**City of Fairhope  
Planning Commission Agenda  
5:00 PM  
Council Chambers  
June 3, 2019**

## Zoning Change: RA to PUD

Preliminary Plan  
**Live Oak Estates**  
City of Fairhope, Baldwin County, AL  
PREPARED FOR: Breland Homes Coastal, LLC

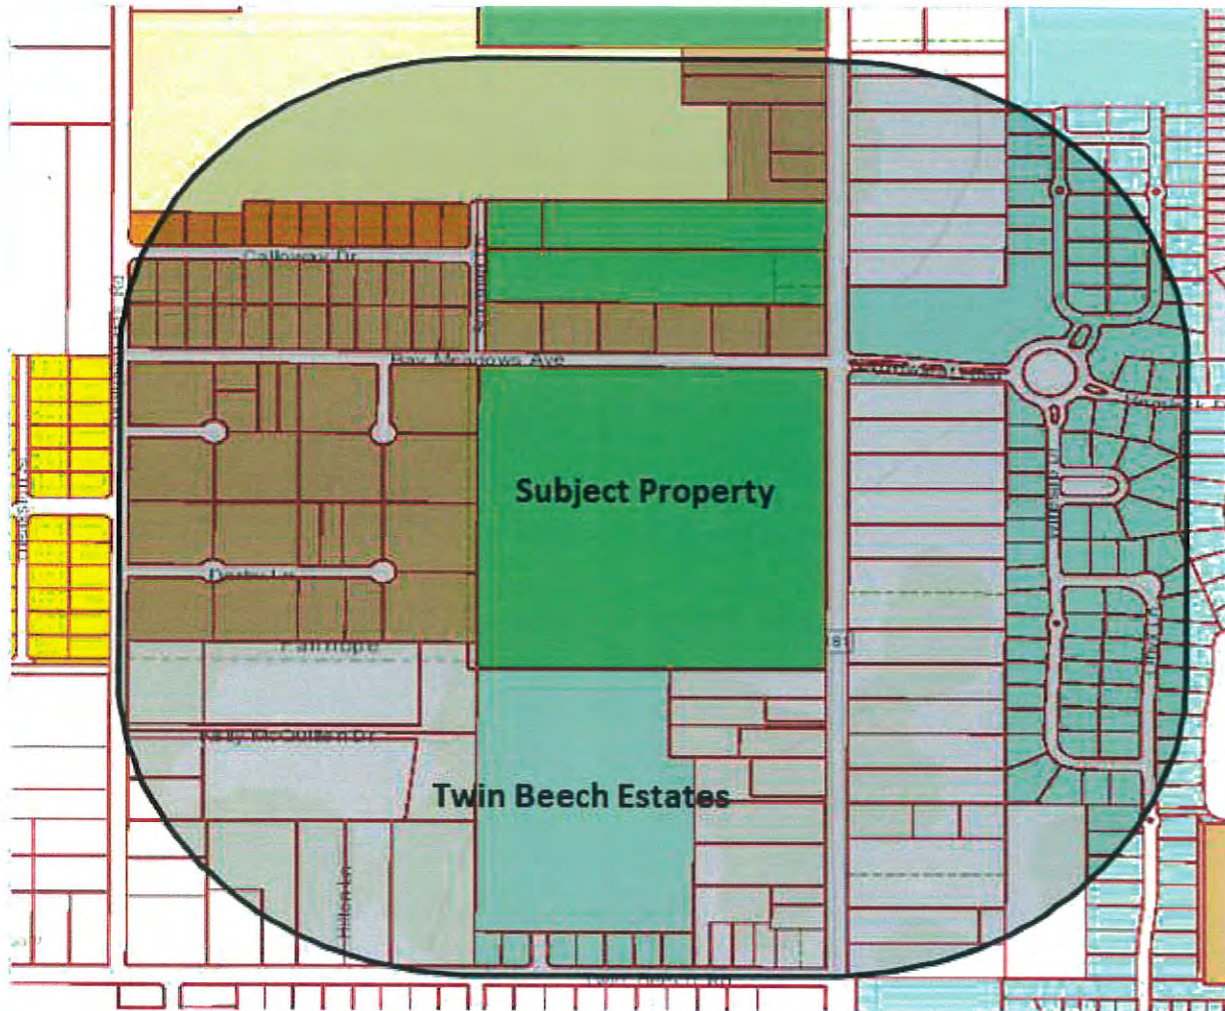
According to the site plan submitted pursuant Article II.C.2(a), the requested 107 single-family residential lots result in a requested density is 3.18 units per acre. Staff conducted a compatibility analysis which indicated an acceptable compatible density of 2.01 units per acre.

Weighted Actual	1.089396
Weighted Allowable	2.940308
Weighted Average	2.014852
Requested Density	3.18

The site plan also indicates a green belt along the perimeter separating the subject properties lots and those adjacent to the property. The buffering and separation are used as a mitigation measure between dissimilar lot sizes. The site plan also shows 3 different points of access. Two are from Bay Meadows Ave. and one uses a connection to Twin Beech Estates which has the same density and similar lot sizes.

The shaded area represents the ¼ mile buffer.

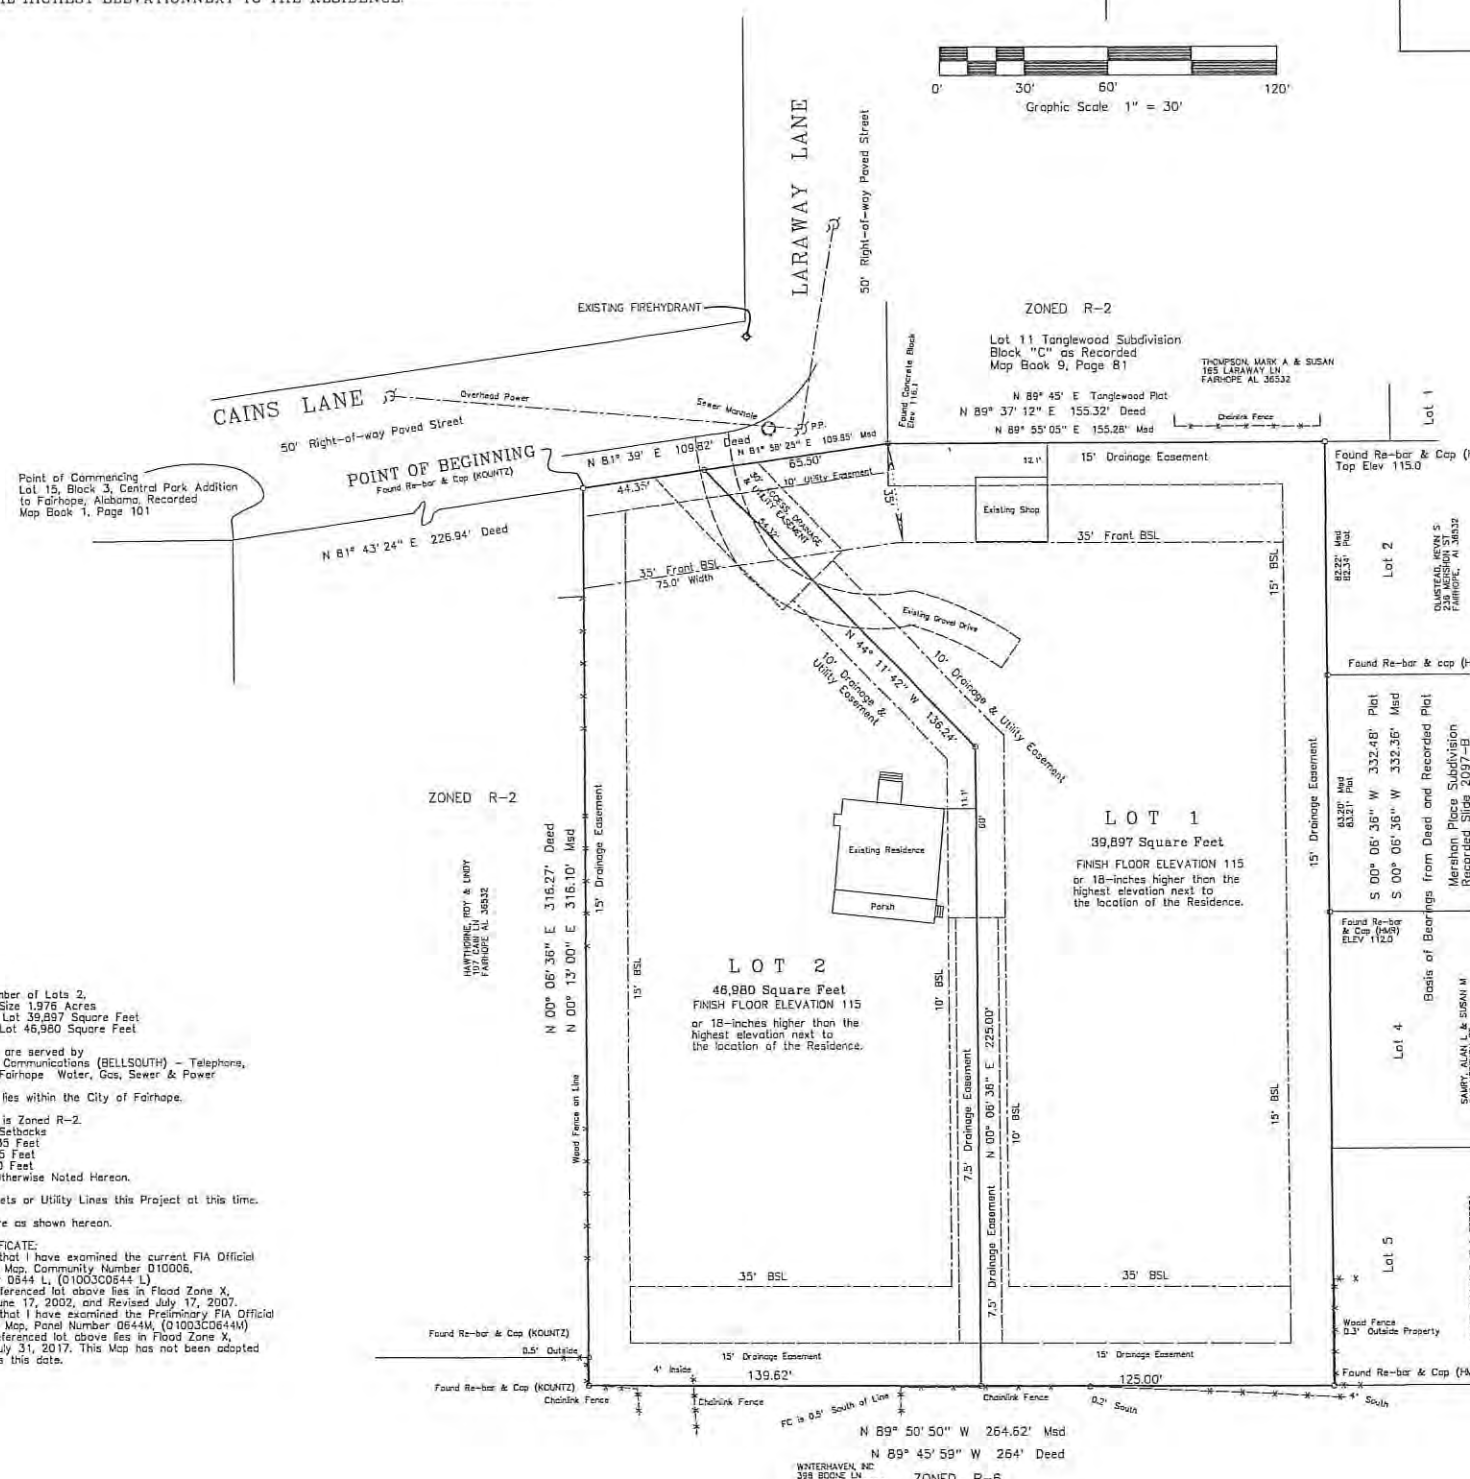
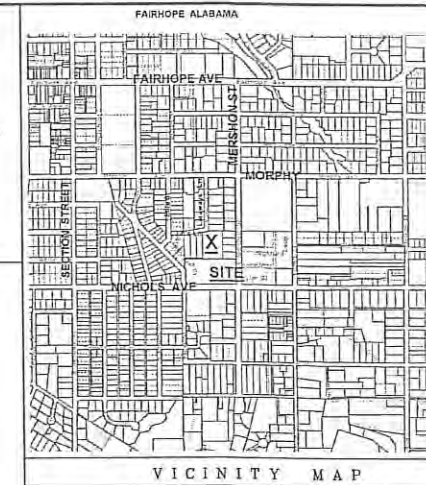
1. Removal of the existing shop building on Lot 1.
2. Granting a waiver for the sidewalk exemption and adding a pedestrian easement if the Planning Commission desires this for future residents.

THE EXISTING SHOP ON LOT 1 SHALL BE REMOVED BEFORE A BUILDING PERMIT FOR THE NEW RESIDENCE CAN BE OBTAINED.

*RIVER PLACE  
PRELIMINARY PLAT  
BALDWIN COUNTY, ALABAMA*

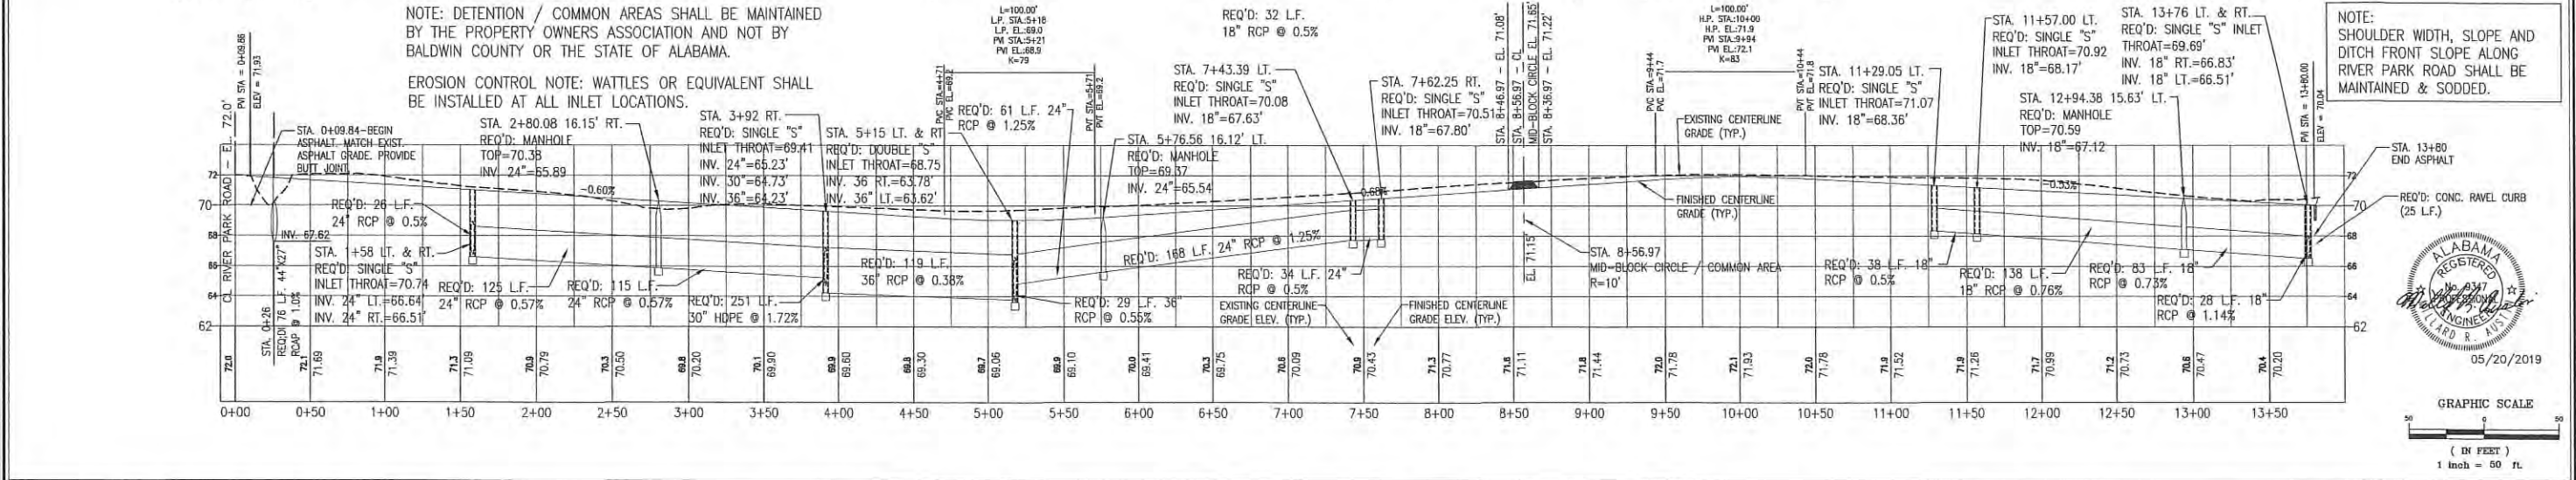
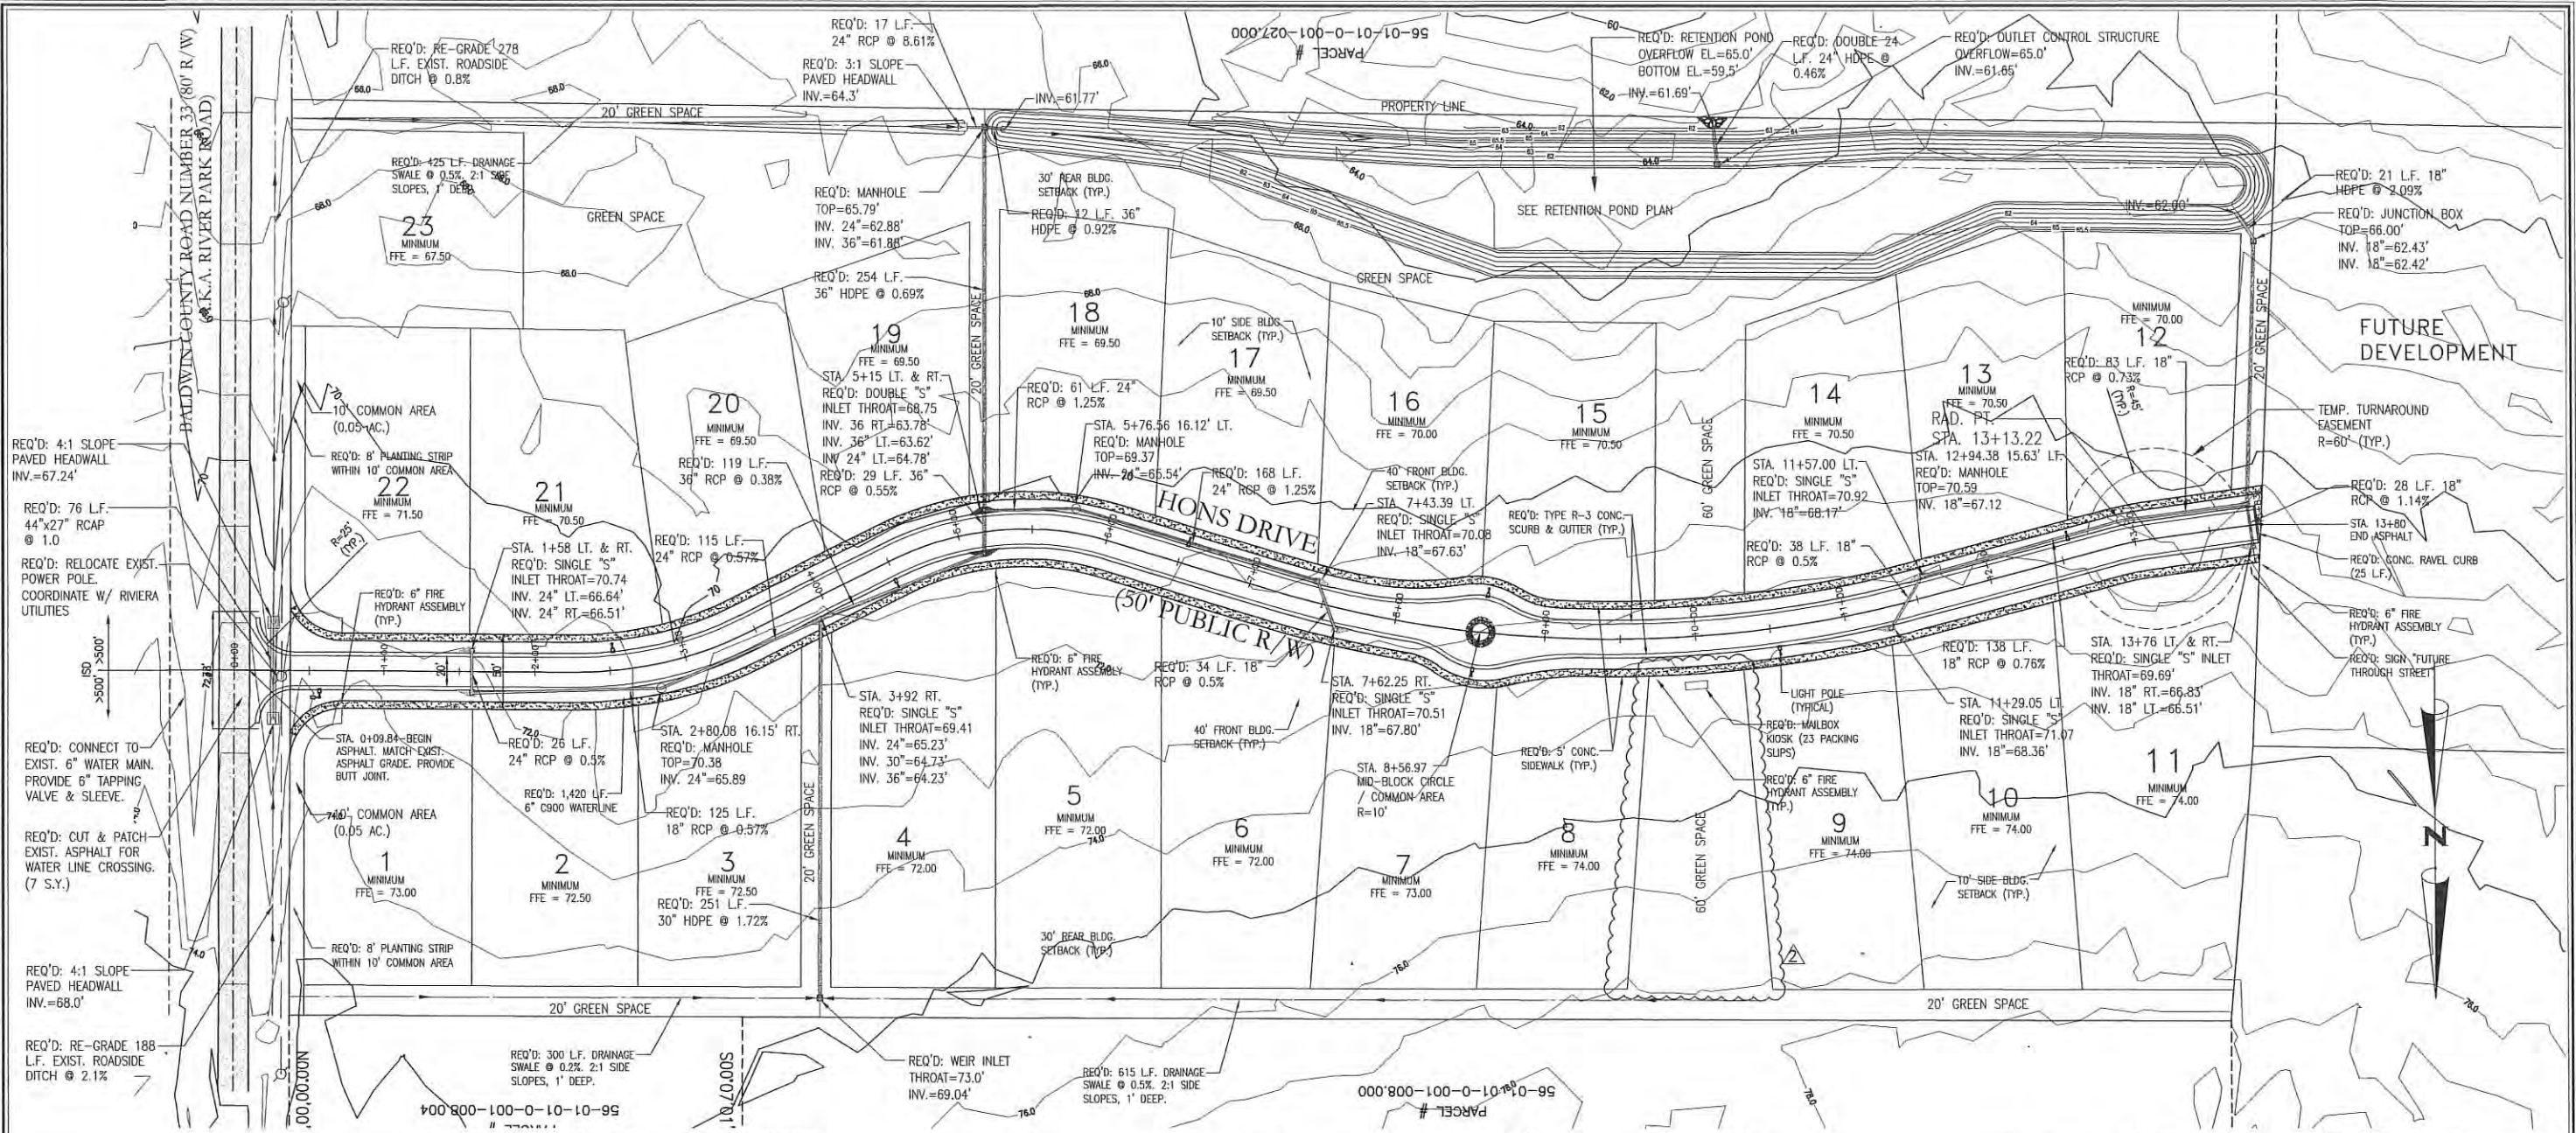
1. Add note on plat that the detention/common areas shall be maintained by the property owner’s association and not by Baldwin County or the state of Alabama. (As noted on sheet 6 of the drawings.)
2. Add curve and line data to the plat.
3. Will need a copy of the County’s review and the County’s Engineers Certificate of Review.
4. Closeout testing reports shall include mandrel tests on all HDPE storm water drainage pipes.

1	ADDED STREET SIGN AND LIGHT POLES	05/13/2019
2	REVISIONS PER CITY COMMENTS	05/20/2019
